PRELIMINARY DECISION OF CATEGORICAL EXCLUSION

CITY OF FORT WAYNE
ADDENDUM # 6
HUFFMAN SEWER SEPARATION – PHASE 1 PROJECT
SRF Project WW 14 31 02 07

Project Name and Address:	**PER Addendum #6** **Huffman Sewer Separation – Phase 1 Project** City of Fort Wayne 200 East Berry Street, Suite 270 Fort Wayne, IN 46802
SRF Project Number:	**WW 14 31 02 07**
Authorized Representative:	Kumar Menon, Director of Public Works

HUFFMAN SEWER SEPARATION - ADDENDUM 6

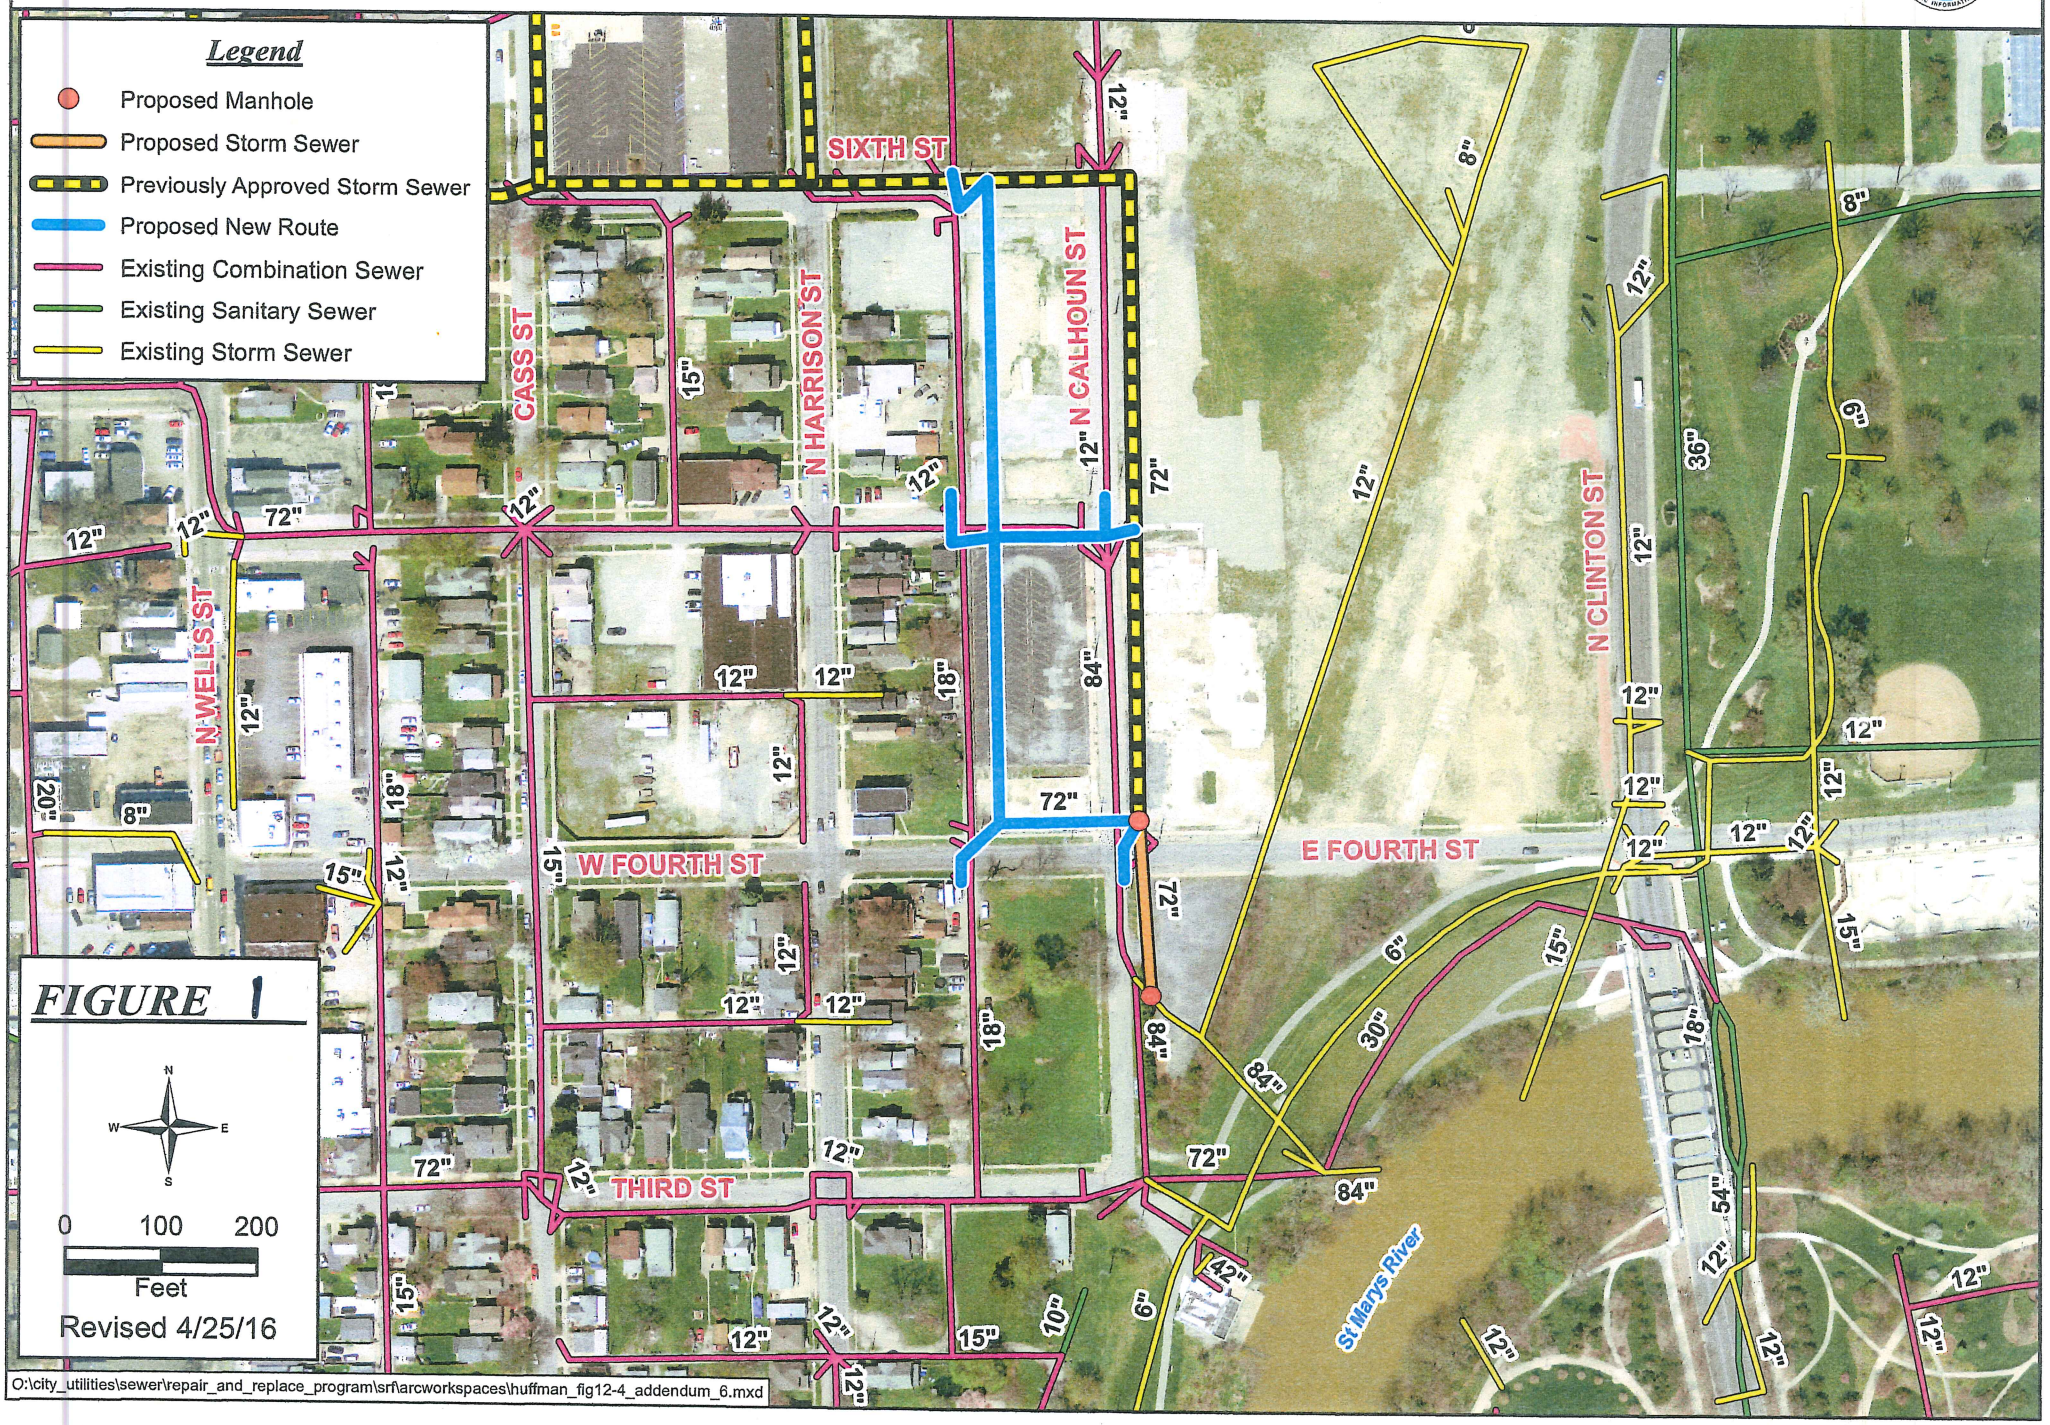
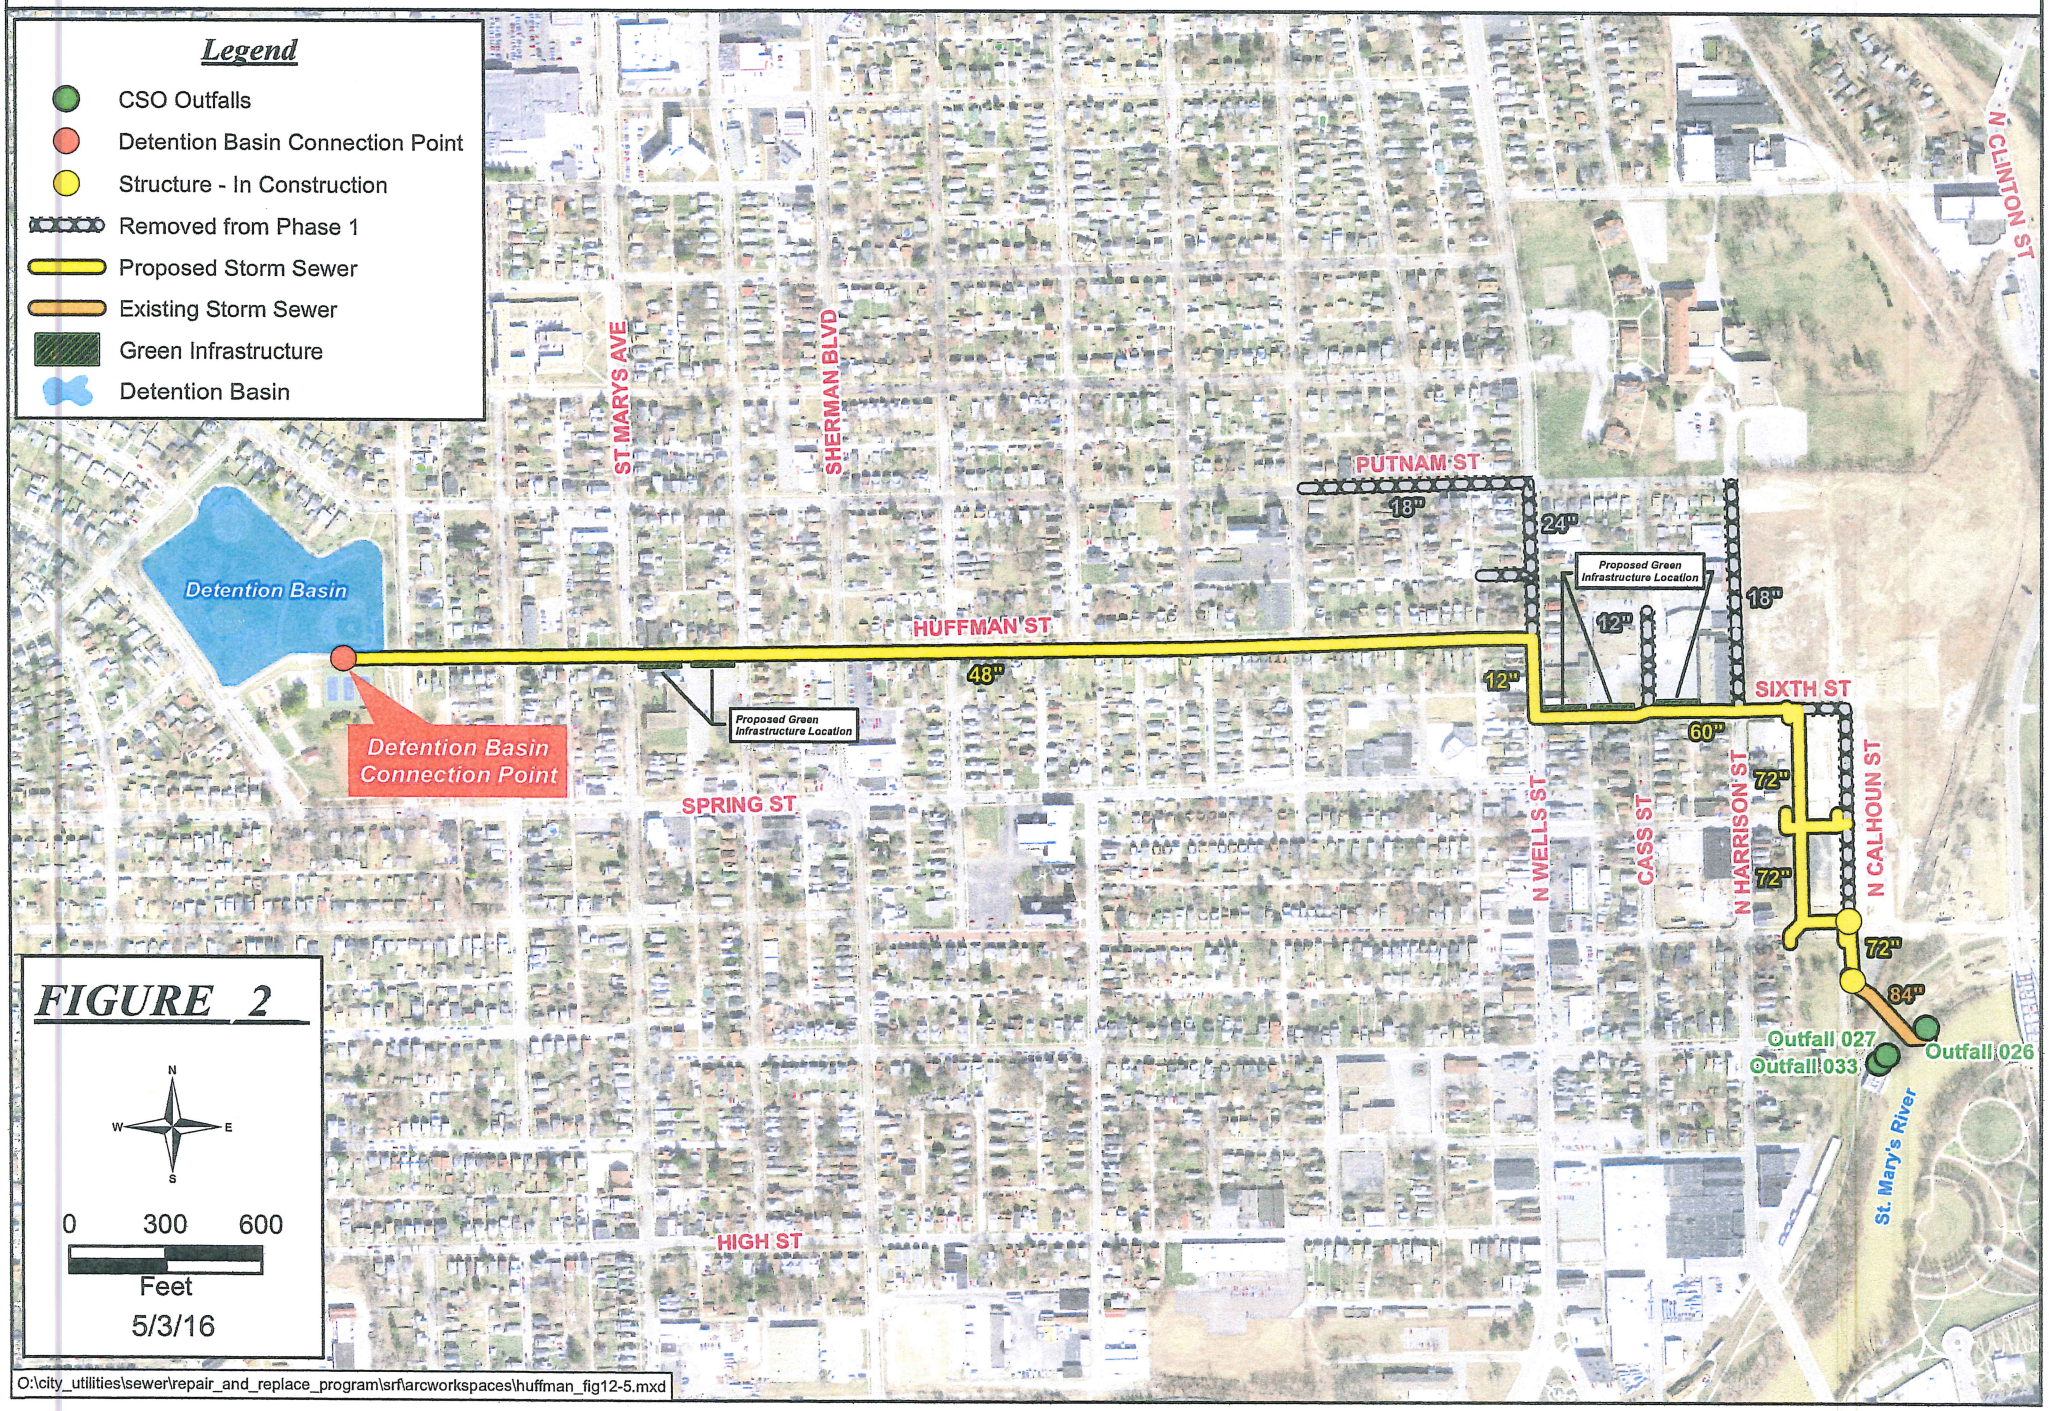
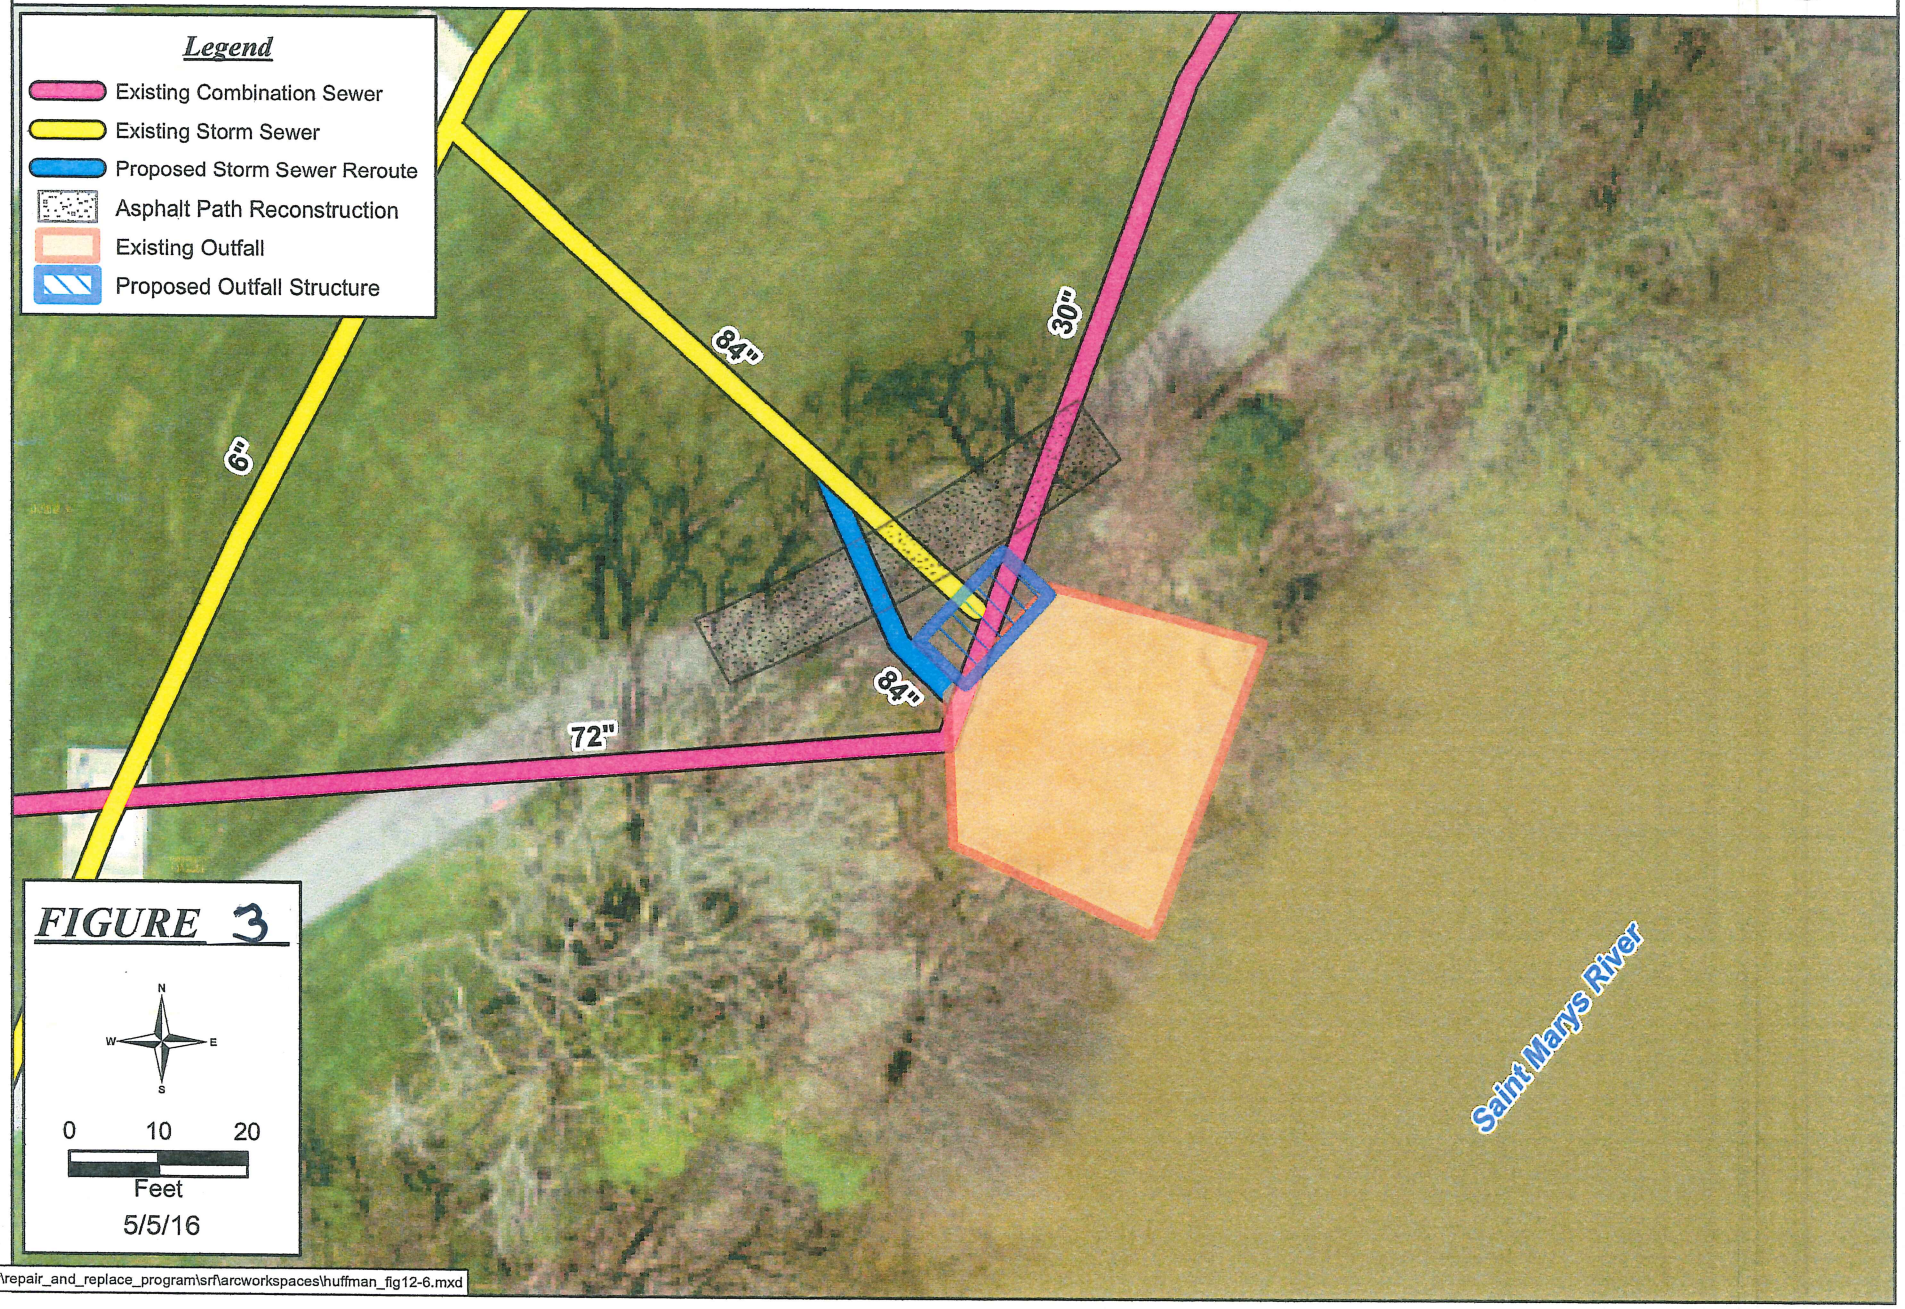
Fort Wayne had to revise the previously approved Huffman Sewer Separation – Phase 1 project, since there were a few issues encountered during design.

The proposed revisions include: moving storm sewer drains that are not part of the main line storm sewer from Phase 1 to Phase 2 due to cost; rerouting the proposed 72-inch storm sewer from North Calhoun Street to an alley between North Calhoun and North Harrison Streets due to easement issues; installing approximately 300 feet of 72-inch storm sewer from an existing manhole at the intersection of East Fourth and North Calhoun Streets south to an existing 84-inch storm sewer that was previously scheduled to be constructed under a separate contract; modifying the existing outfall structure by adding an additional structure that will raise the headwall to an elevation above the 100-year floodplain at the St. Mary's River; replacing the deteriorating flap gates on the existing outfall structure; rerouting a 12-inch storm drain to the existing outfall structure due to a conflict with the proposed construction at the outfall structure; and reconstructing the asphalt trail near the outfall structure. See Figures 1, 2 and 3.
